ACE/ATRIUM 11 Critical Power Correlation - RAIs

ANP-10335Q1NP
Revision 1

Topical Report

A boiling water reactor ACE/ATRIUM™* 11 critical power correlation topical report is provided in Reference 2. This document provides responses to a Request for Additional Information (RAI) (Reference 1) on that topical report.

Figure 1. KATHY Thermal-hydraulic Test Loop

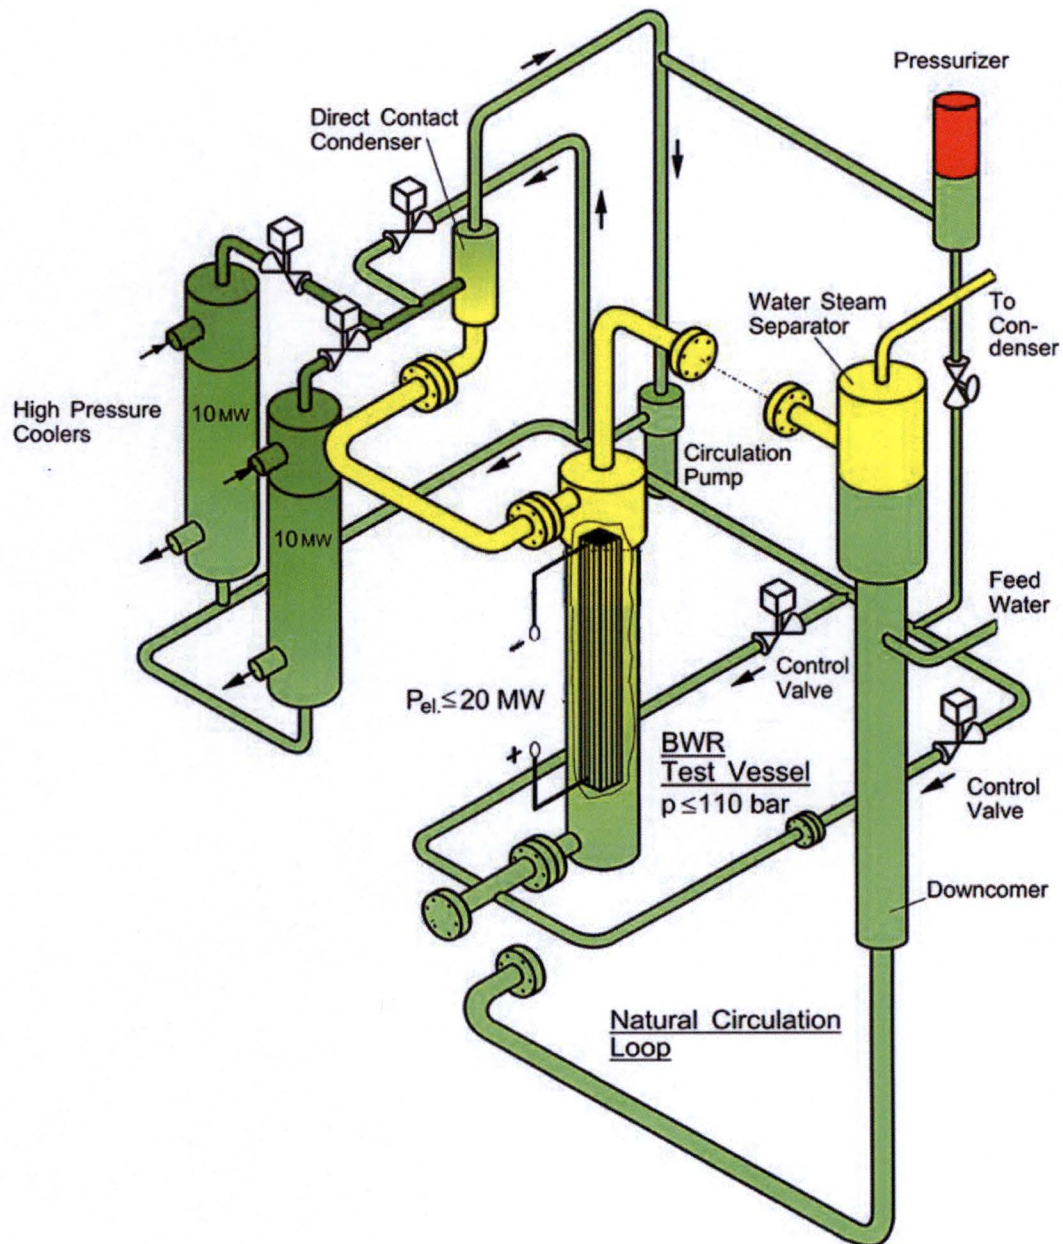
Please provide references to documents describing the test loop and facility in greater detail, as well as the quality assurance program to be applied.

All of the data for the ACE/ATRIUM 11 critical power correlation were taken at the AREVA KATHY thermal-hydraulic test loop located in Karlstein, Germany. Figure 1 shows that the thermal hydraulic test facility is a high pressure water heat transfer loop containing a test vessel (shown in Figure 2) with the test assembly and upper and lower bus bars, high pressure coolers, a direct contact condenser, an electrically heated pressurizer, and the main circulation pumps. Two inlet flow lines of different sizes are shown. The different sizes allow fine control of the flow rate over a broad range. The test loop is rated at [] The DC power supply consists of four thyristor controlled rectifiers, providing a total electrical current of []
